City of Puyallup
Planning Division
 333 S. Meridian, Puyallup, WA 98371
 (253) 864-4165
 www.cityofpuyallup.org

DEVELOPMENT REVIEW TEAM (DRT) LETTER	
DRT #	I
PERMIT #	PLVAR20210001
PROJECT NAME	Pioneer Mixed Use Landscape Variance
PERMIT TYPE	Variance
PROJECT DESCRIPTION	New mixed use development along E Pioneer seeks reduction of landscape buffers to help meet driveway and fire apparatus turning hammerhead.
SITE ADDRESS	708 E PIONEER, PUYALLUP, WA 98372; 702 E PIONEER, PUYALLUP, WA 98372;
PARCEL #	0420273238; 0420273257;
ASSOCIATED LAND USE PERMIT(S)	
APPLICATION DATE	December 13, 2021
APPLICATION COMPLETE DATE	January 03, 2022
PROJECT STATUS	<u>Active Development Review Team (DRT) review case – resubmittal required.</u> Please address review comments below and resubmit revised permit materials and by responding in writing to the remaining items that need to be addressed.
APPROVAL EXPIRATION CONDITIONS	N/A – Active permit application, not approved; Active permit application, not approved; Pursuant to PMC 20.11.022 regarding inactive applications, any and all pending land use applications or plat applications shall be deemed null and void unless a timely re-submittal is made to th

SITE PLAN
SCALE: 1" = 30'-0"

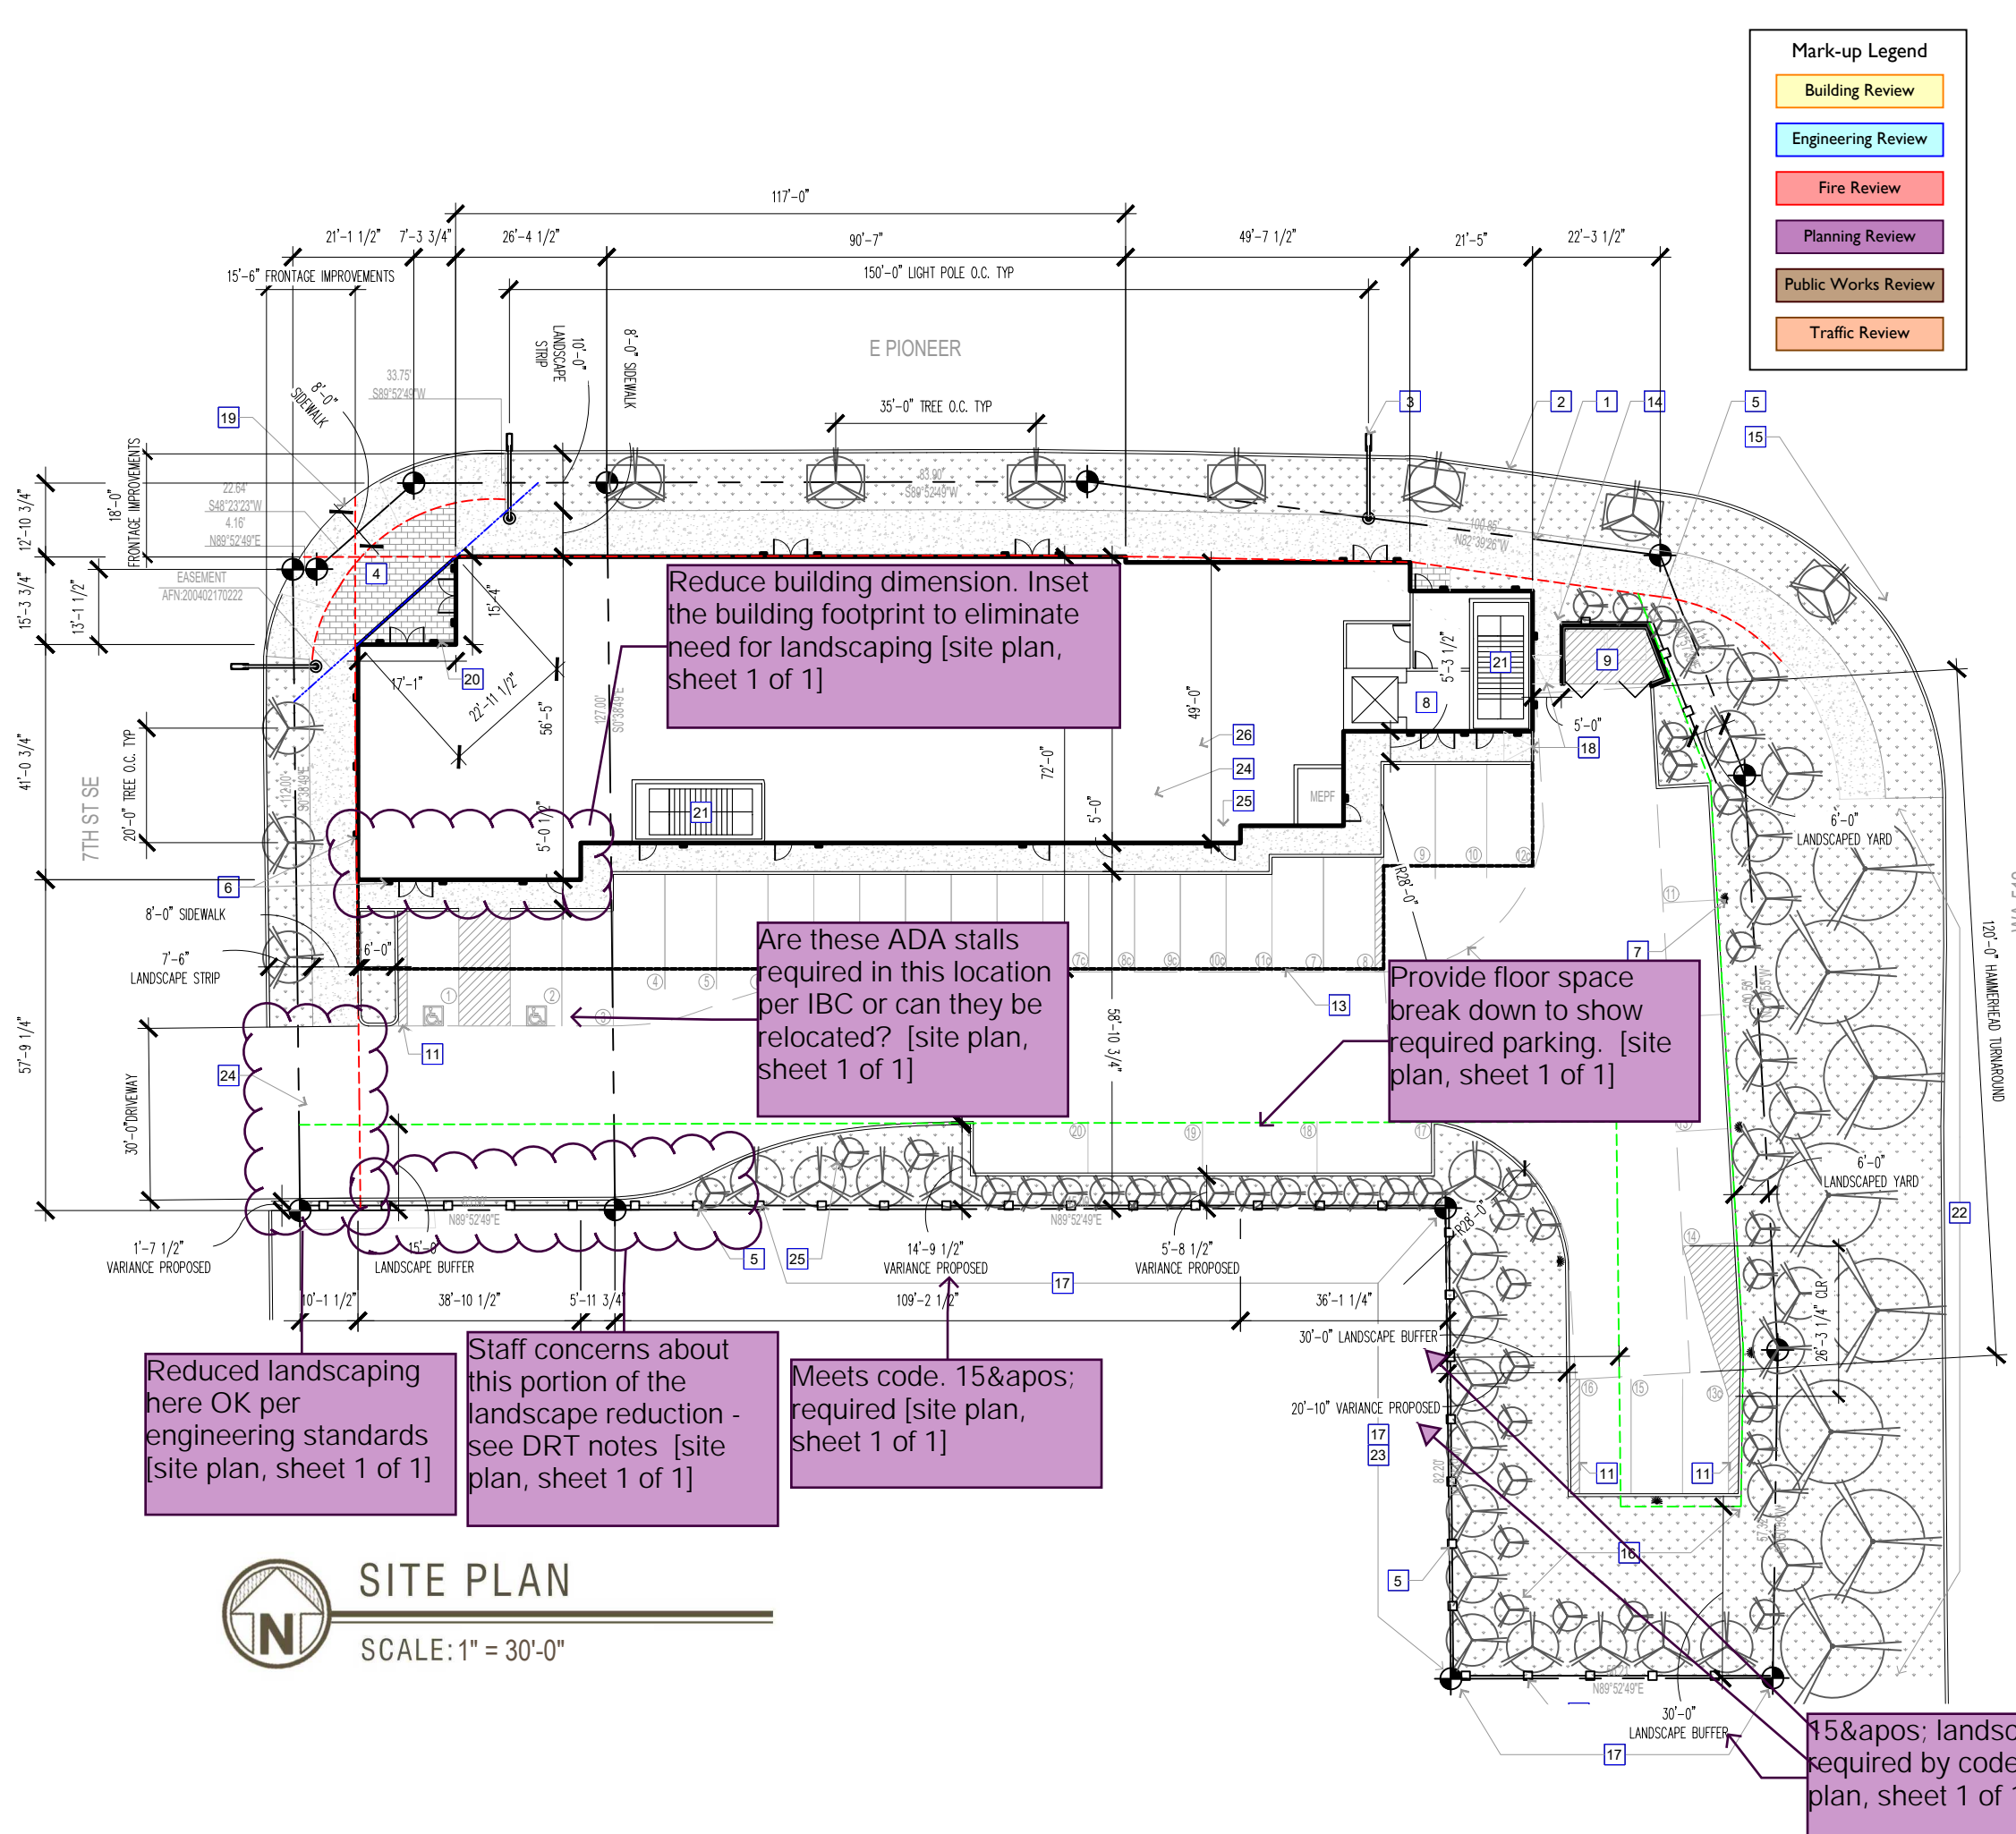
- 1. To determine code compliance with parking lot the following need to be shown on plan. Riser Room, FDC, PIV, and Fire Hydrants. These items can not be blocked by a parking stall. The Riser Room requires direct access from the parking lot.
- 2. Fire Truck turn-around needs dimensions on both sides of the hammer head.
- 3. 12c parking stall will impact the turn-around depending on what type of vehicle parks there. Parking spots can not encroach into fire lane. This spot may need to be removed.

- To maximized intersection/Driveway spacing, 7th St SE access must be located as far south as possible (3ft from the south property line). The commercial driveway shall be 30ft wide at City ROW. Once on private property, the driveway shall re-align to meet 15ft buffer requirements. The re-alignment shall minimize the partial removal of the landscape buffer.
- Approval of this variance does not guarantee full access at driveway location. Further analysis required to determine access feasibility. See previous pre-application notes for all traffic engineering requirements.

- PMC 20.30.030 (9) allows a 15' buffer along the RM-20 / CBD zone change boundary. This applies to all of the southern property lines that are adjacent to the RM-20 zoning district, which includes the western and southern property boundaries adjacent to the southern portion of the hammerhead. The site plan denotes that a 20-foot 10-inch landscape buffer variance is proposed along the southern section of the hammerhead. Please continue to denote landscape buffer width but remove reference to "variance proposed."

- The landscape buffer reduction variance request is required for the proposed driveway location and on-site parking. Your variance criteria response only discusses the driveway placement and fire access and does not describe why the landscape buffer should be reduced for on-site parking. Sufficient building details , including proposed interior uses, dwelling units, etc. are required with your resubmittal to demonstrate the minimum parking spaces required so Staff can compare the minimum required parking spaces against the site plan design and parking count. Revise all documents to provide the necessary information to justify the landscape buffer reduction for on-site parking.

- Planning staff understands the need for the driveway approach location on 7th Street SE to be as far south of the Pioneer intersection as possible for the purposes of compliance with engineering traffic safety standards (driveway spacing from arterial intersections). Staff understands that would result in a landscape buffer reduction to roughly 1-foot, 7-inches at the driveway approach at the right of way line and slightly interior to the site as the driveway approach tapers to the interior private driveway. However, staff anticipated the site plan layout to taper the driveway north immediately after the ROW approach driveway to widen the landscaping back to the standard 15' requirement. Elimination of the buffer for the 39'+ internal to the site appears to be the result of a bump out in the building footprint just north of the ADA parking stalls.

- Without a detailed analysis from the applicant regarding interior floor layout, staff is not able to support the landscape buffer being reduced less than 15-feet for the entire 39-feet in length that is needed to accommodate a building bump-out. A detailed explanation of why the landscape buffer should be reduced to allow for the building bump-out and ADA parking stalls is required. Please note that City staff is unlikely to support any landscape buffer reduction as a result of the building bump-out since the building size could be reduced and ADA parking stalls could be placed elsewhere on site (where allowed by IBC). The site plan should be updated to show the landscape buffer tapering back to 15-feet that starts at the property line, and thus avoiding the need for a variance. The site plan may simply be shown to represent a footprint that is too large to accommodate needed landscaping, drives, parking and other site features, as oppose to a special condition based on the circumstances of the lot and its surroundings – such findings would result in a denial of the variance by the Examiner.

- To ensure that the proposed fence meets the intended screening requirements, a fence detail plan shall be submitted.
